NOTICE OF PERMIT

Attached is Modification #38414-003-SC to Construction Permit 38414-001-SC, issued pursuant to Section(s) 403.087(1), Florida Statutes. Since only the expiration date was modified, and in order to conserve resources, only **Page 1 of 24** of modified Construction Permit 38414-001-SC is attached. Please replace the existing Page 1 of 24 with the attached page. Since Specific Condition #2.d. states that construction shall be "completed no later than October 1, 1999, **or as otherwise approved by the Department,**" this condition was not changed, and the Department approves of the proposed completion date of **June 30, 2000** by way of this letter. All other conditions of the existing permit remain unchanged and in effect.

RE: Hardee County Regional Landfill, Liner & Tank
Permit No.: 38414-001-SC, Hardee County

FIGURE 1.

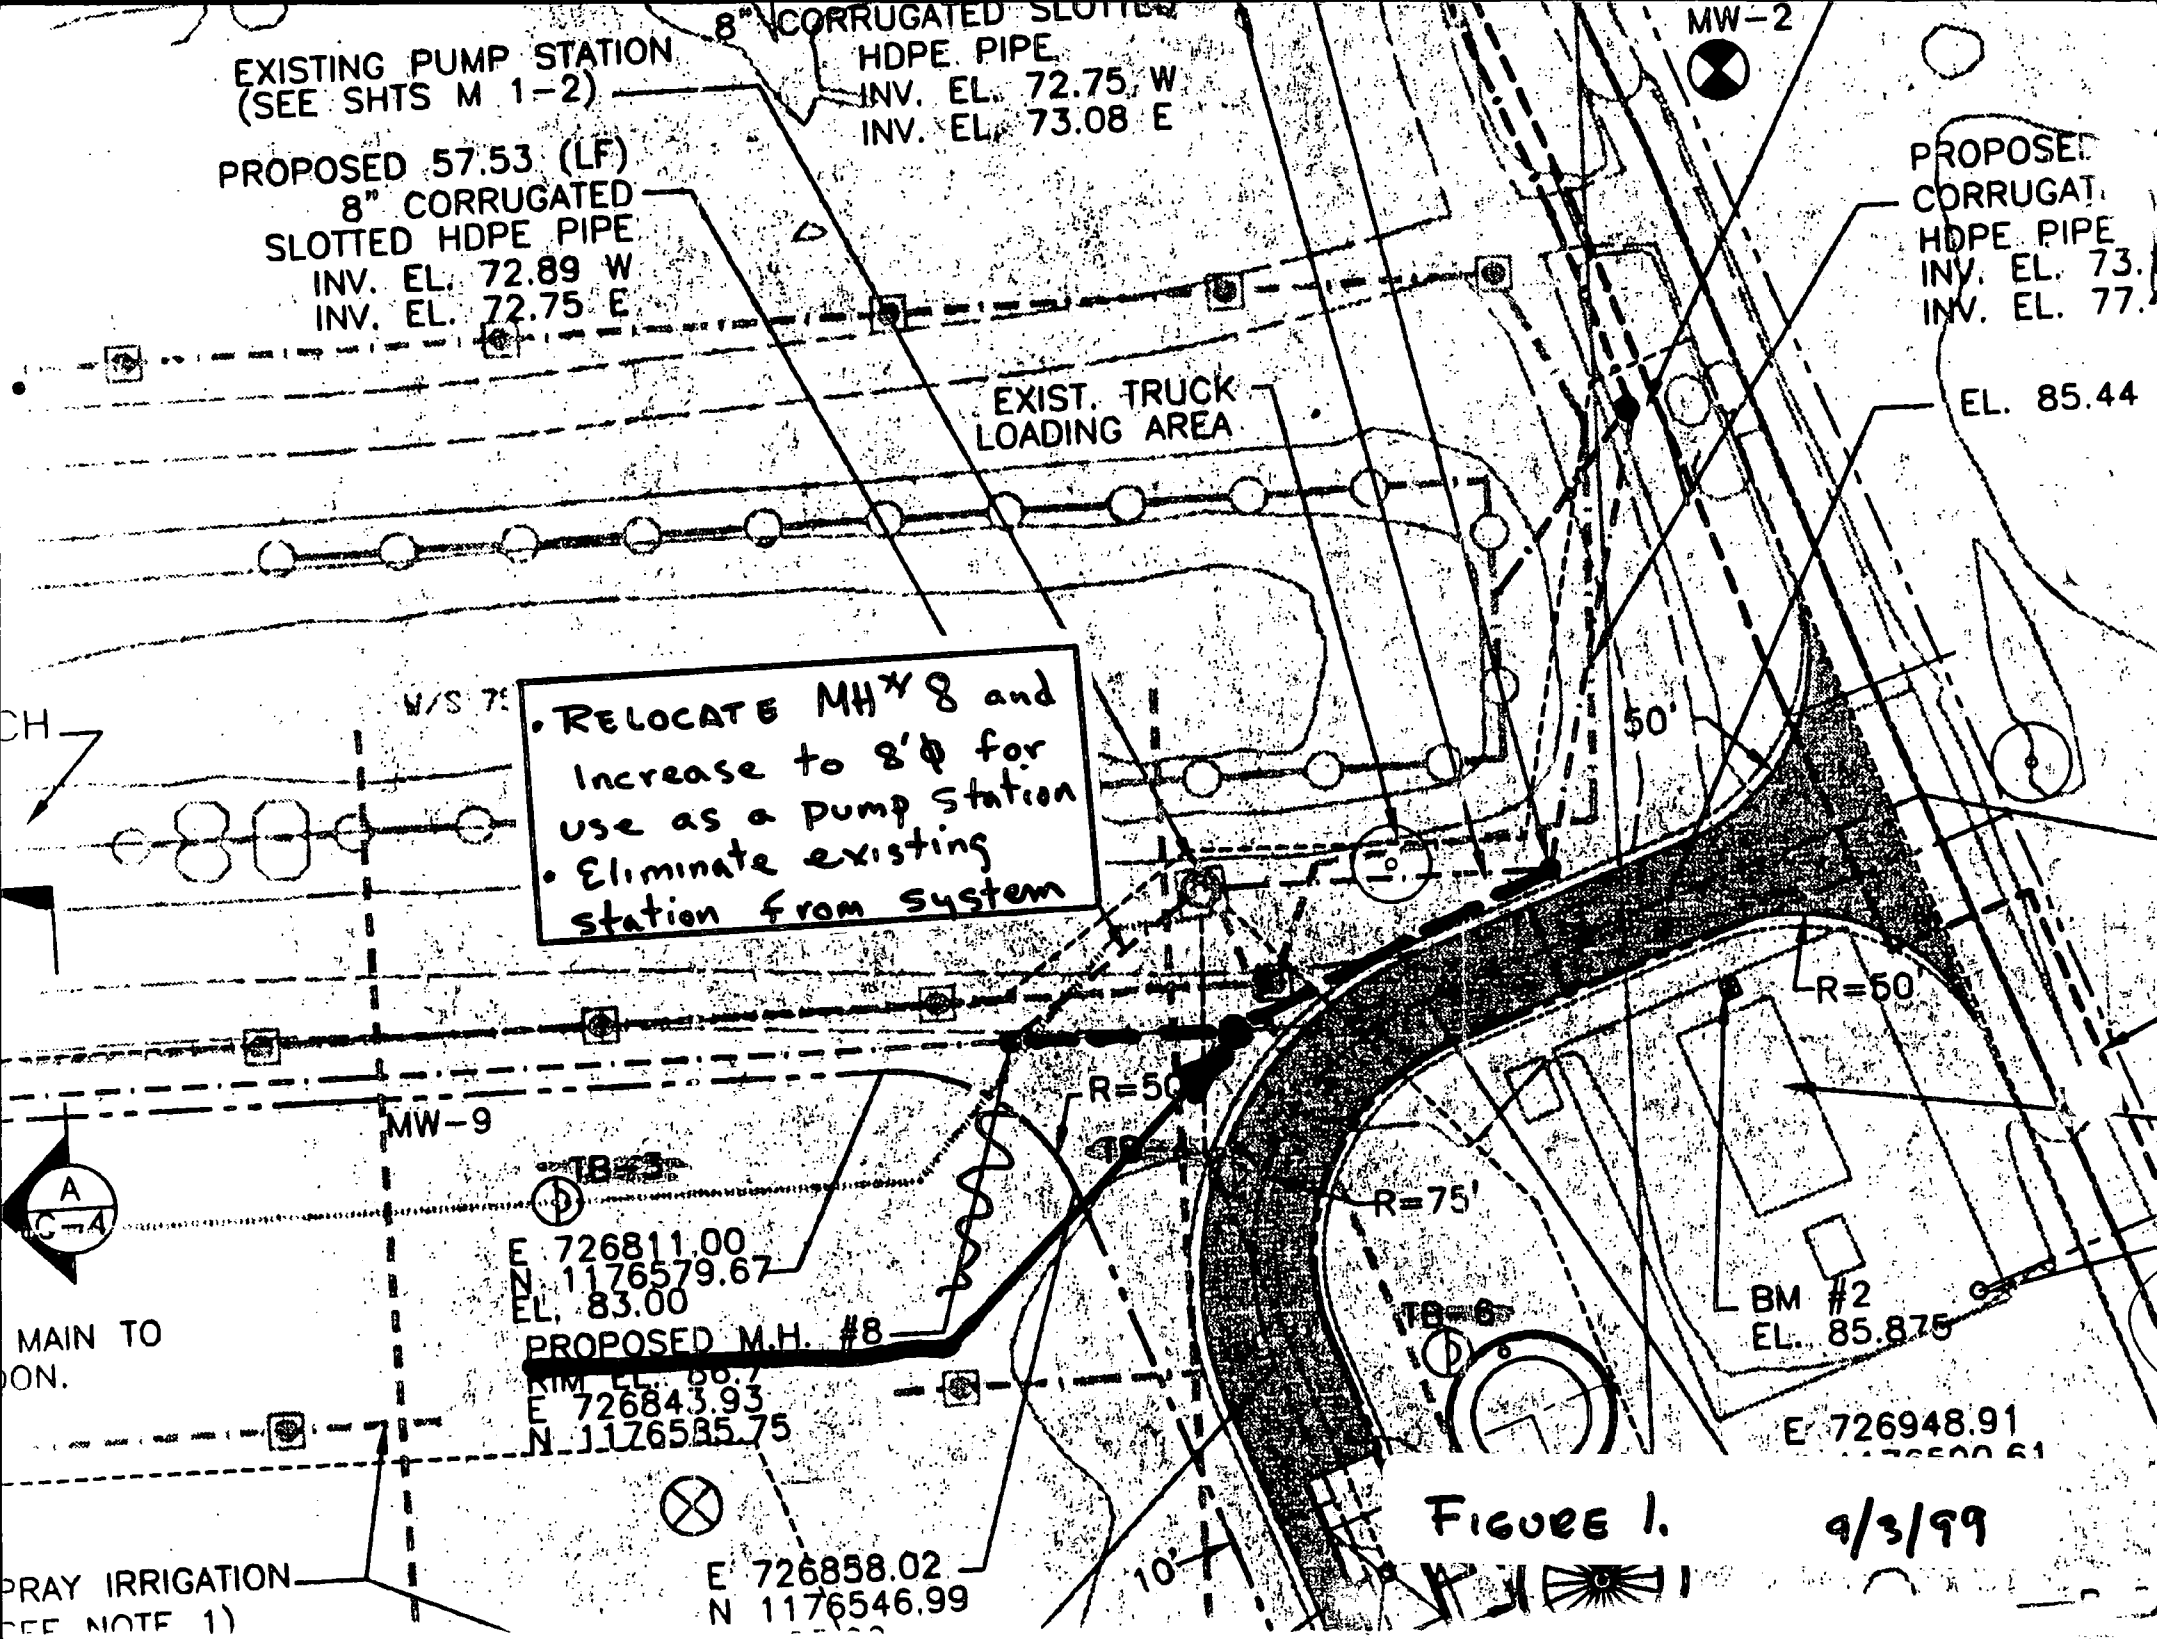
The contractor has proposed that we modify the leachate collection system design to eliminate the use of the existing pump station in the system. He proposes to move manhole number eight about 120 feet further east, up-size the manhole from a 4-foot diameter to an 8-foot diameter manhole, and use this manhole as the pump station. See Figure 1 (dated September 3, 1999).

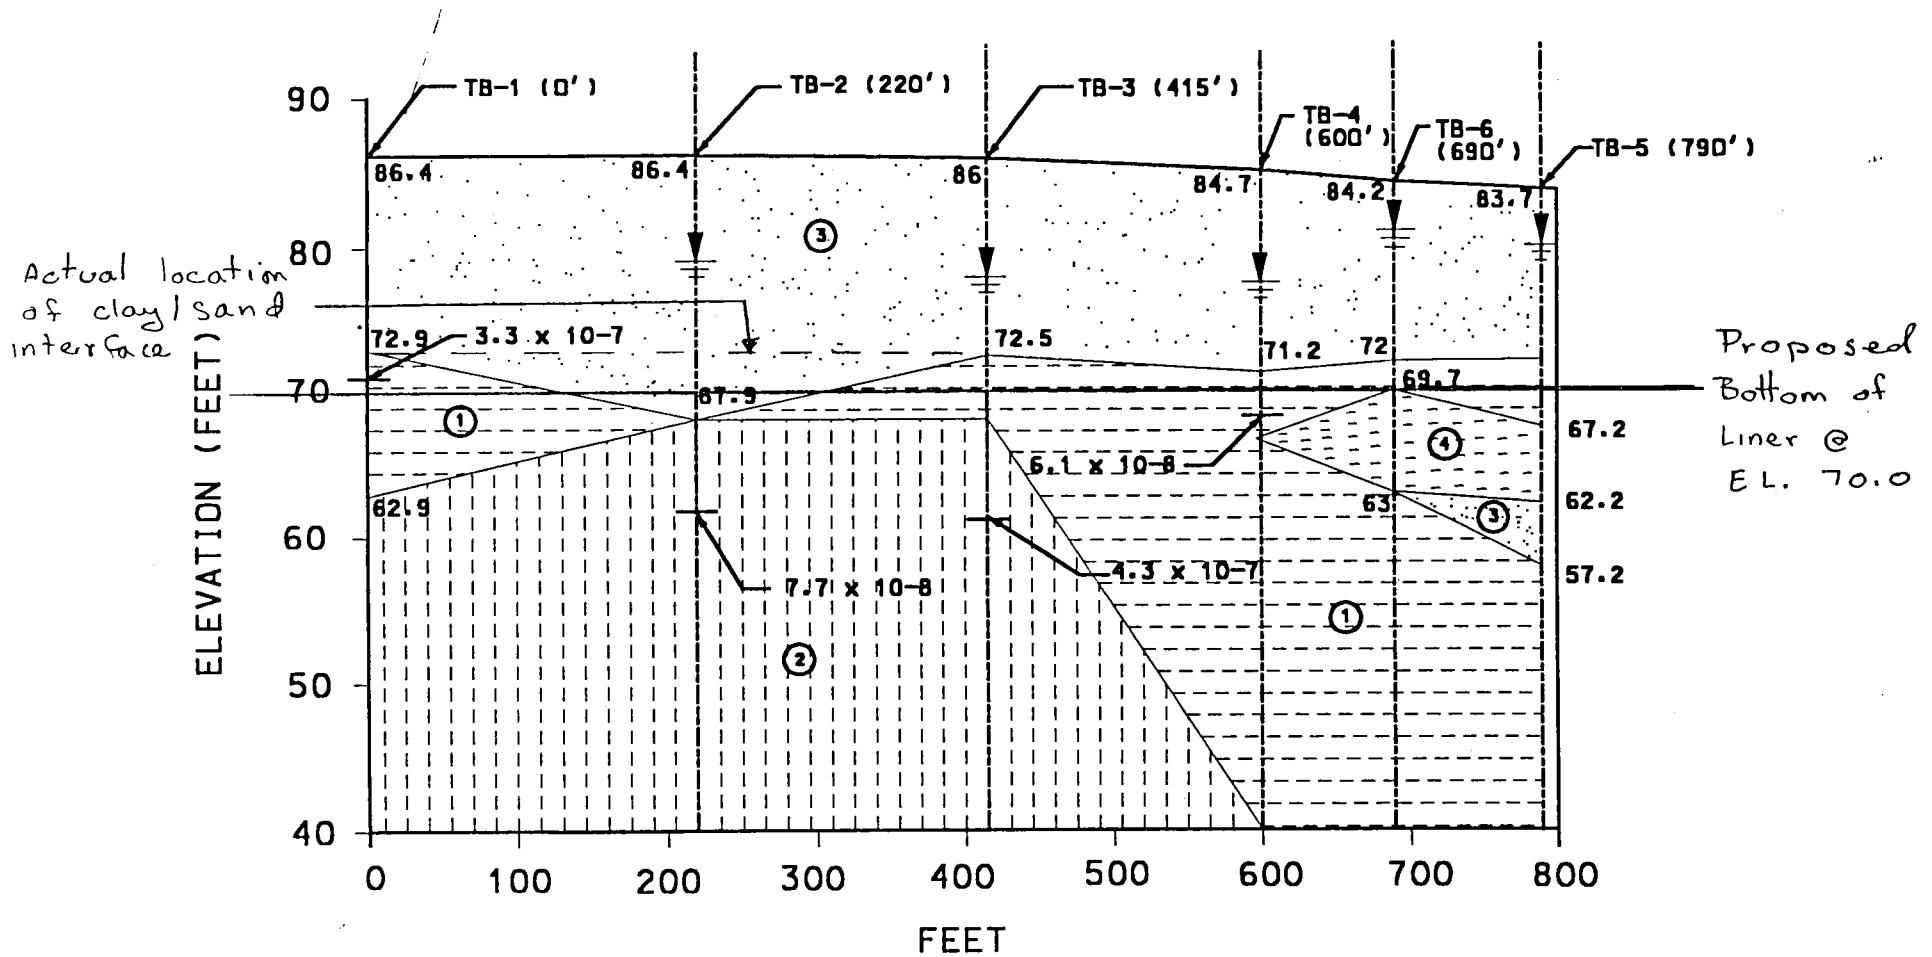
Please see the attached geologic fence diagram. I am proposing that the bottom of the liner be keyed into the clay at elevation 70.0, approximately 13 feet below the ground surface. This would provide the 1.5 feet of key into the clay layer at boring locations 1,3,5 and 6. At boring location 2, I believe that the lower depth to clay at this location is an anomaly - the clay interface is more likely at about elevation 72.0. At boring location 4 we are very close to having the 1.5 foot of key - within three tenths of a foot. This still gives us 1.2 feet of cover over the liner. Since there is already about 2,200 feet of liner existing that was installed to the clay layer 10-15 feet below ground surface, I see no environmental benefit gained by excavating 25 feet to elevation 60.0 to install the last 400 feet of liner. The leachate collection system adjacent to this new liner will be installed below the water table. I believe that the functional benefit that the LCS provides to the water table elevation in this area mitigates the "risk" of local variations in the consistency or depth of the clay. Please call me Monday to discuss this proposal.

In accordance with specific condition no. 5b of the referenced permit, please find attached the following information from the Contractor:

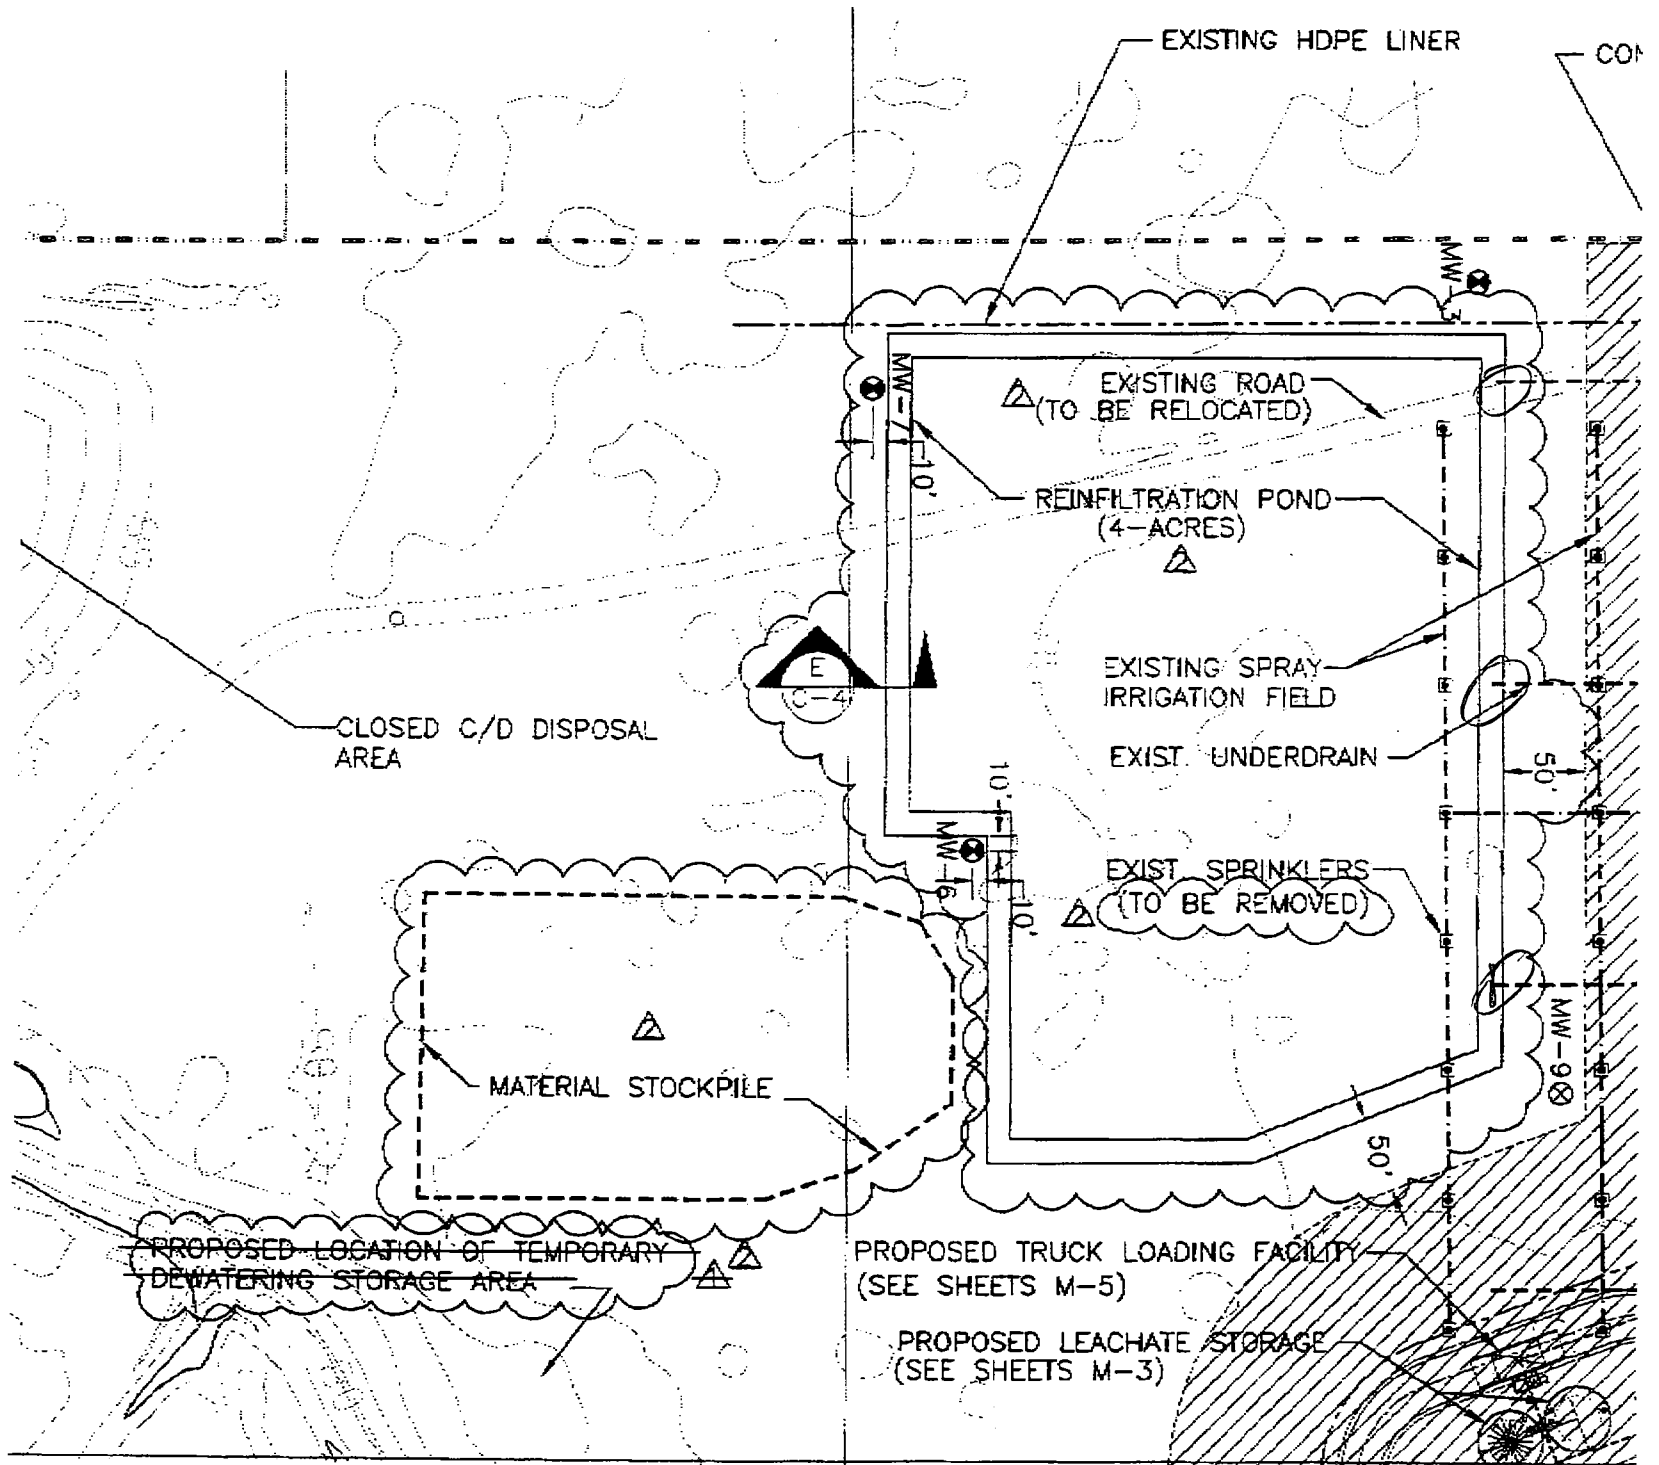
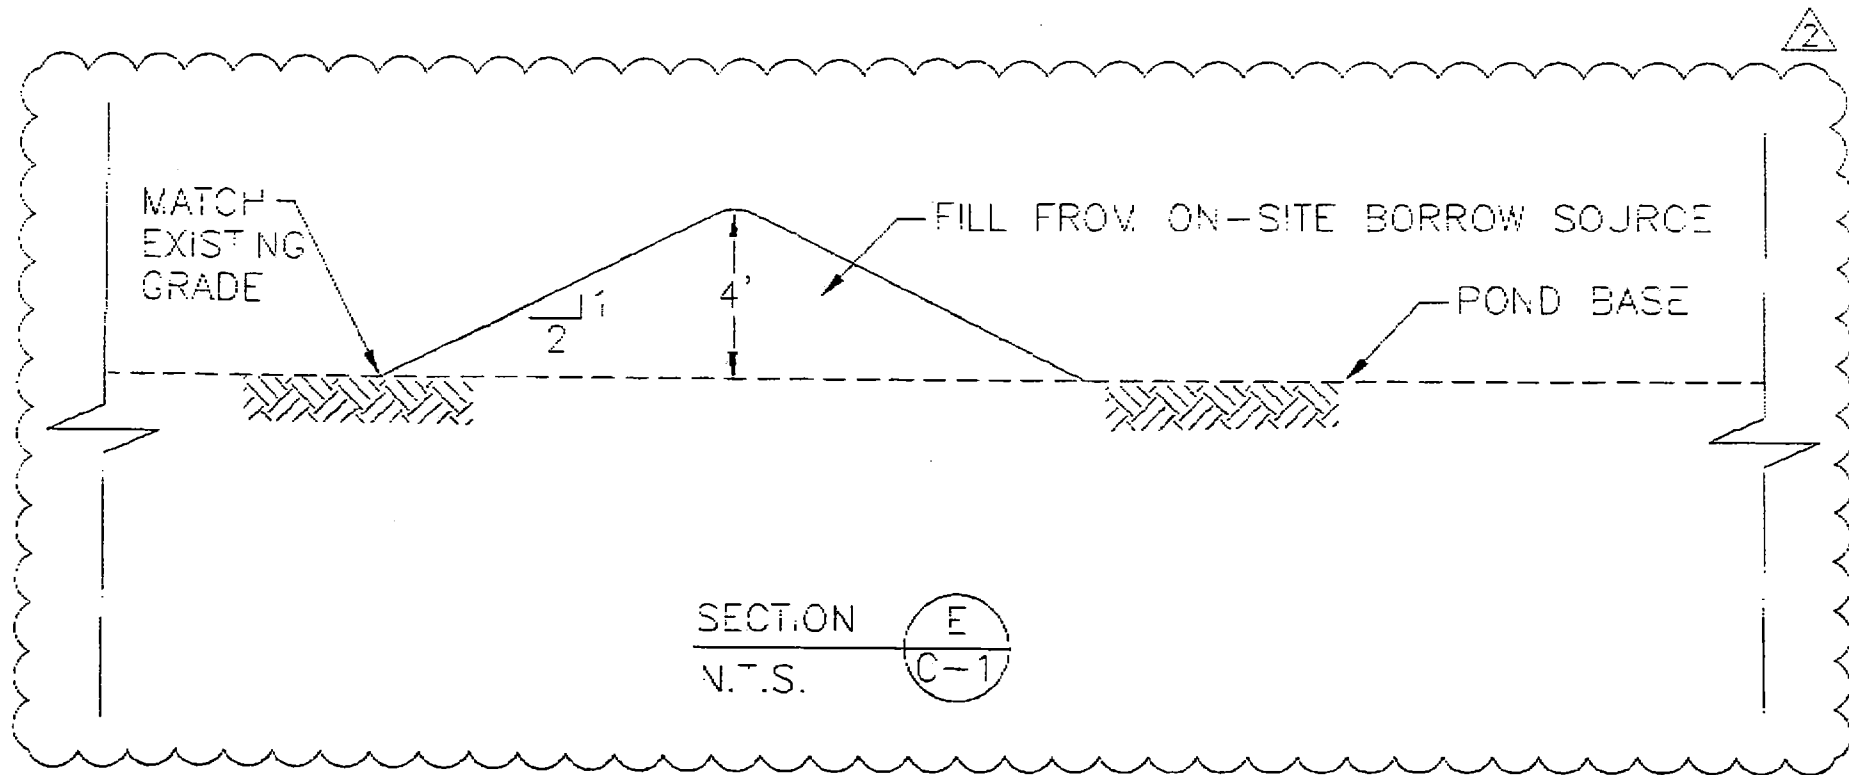
- b. Response #15.b. indicates that Sheet C-2 shows the location of the proposed "temporary bermed storage area." However, this area is shown on Sheet C-1, not Sheet C-2. Please provide details for the construction of this lined area, including, but not limited to storage capacity, berm construction, anchoring details, etc. See also Ms. Allison Amram's memorandum dated January 28, 1998, attached. Please revise this section to include acceptable disposal methods for the dewatered liquids.**
